Subject: Hornsea Project Three - Registration Number 20010316 Oulton Parish Council/written submission of oral

Written submission of Oral representation from Susan Mather on behalf of Oulton Parish Council, including supporting information (Appendix 1 attachment)

OULTON PARISH COUNCIL: written submission of oral presentation at Deadline 10

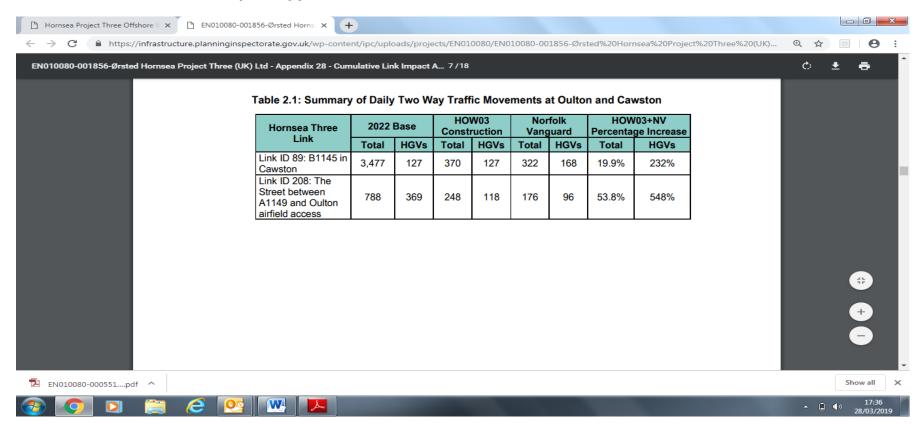
The Old Railway Gatehouse has been assessed for noise and vibration due to road traffic increases, especially HGVs. As a result of the noise and vibration assessment, a road intervention scheme has been proposed as mitigation to reduce potential noise impacts. It should also have been necessary to assess air quality at this property given the close proximity to the road and the increase in proposed HGVs.

OPC would maintain that it is unacceptable for the Applicant to consider that, because of the road intervention scheme introduced to mitigate noise and vibration effects at the Gatehouse, this should somehow obviate the need for an air quality assessment at the same time. The two issues are **entirely separate**, and the level of emissions caused by the increase in all traffic will need to be evaluated and mitigated separately.

Hornsea Three Cumulative impact Appendix 25 LINK 208 (LINK 68 last entry on the Table)

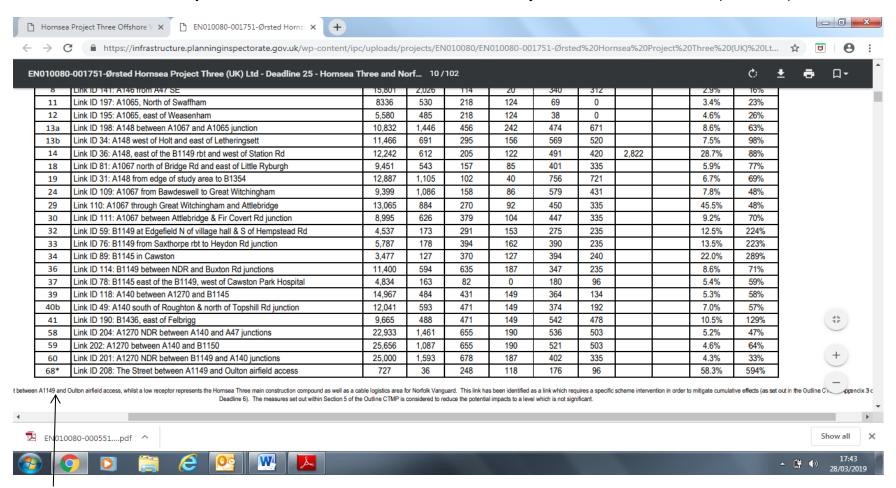
In Orsted's Cumulative Impact Assessment for Oulton there was a <u>548%</u> increase in HGV's, according to Appendix 28 and a <u>594%</u> increase for the same Link in an earlier Appendix 25 - so there is some confusion as to what the actual increase is. Vattenfall's CIA for Oulton was a <u>487.2%</u> increase, so huge variations using the same data. It should be noted that all outcomes would fall within the IEMA guidelines showing that a greater than 30% increase in traffic needed further assessment. (**see Appendix 1 for supporting information.)

Hornsea Three cumulative impact Appendix 28 LINK 208
